## **Department of Community Services Transportation Division**

## MEMORANDUM

SUBJECT Post Hearing (May 9, 2025) - Open record period response

REFERENCE RRV-2024-0004

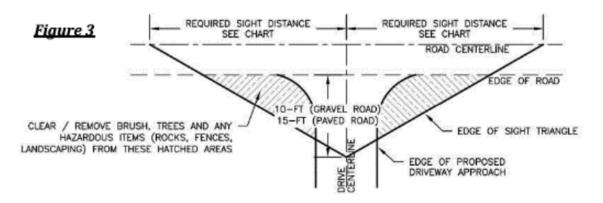
Applicant must submit a revised plan to County Transportation showing the sight triangle (see example below) required to show the vegetation area required to be cleared to the south of "Access 3" in order to meet AASHTO minimum Sight Distance requirements. a. Applicant should show clearly the property/ROW line, with a Survey, and indicate which vegetation belongs within the ROW, and which vegetation may be within the property

line of the neighboring property (18525 Sauvie Island Rd).

- b. If not removed entirely, vegetation should be no higher than 2 feet tall within the sight triangle area
- 2. Once condition 1 has been satisfied, Applicant must submit the plan to County Transportation via email (<a href="mailto:row.permits@multco.us">row.permits@multco.us</a>) or via the See Click Fix App¹ (links can be found below and on the County website) for County Maintenance to clear the vegetation within the County ROW (see applicant's Maintenance Request Exhibit F.3). **Note:** County Transportation Maintenance has no authority to remove vegetation from the neighboring property. Applicant would require a permit to do this instead of County Transportation Maintenance (see MCRR 18.750(G).
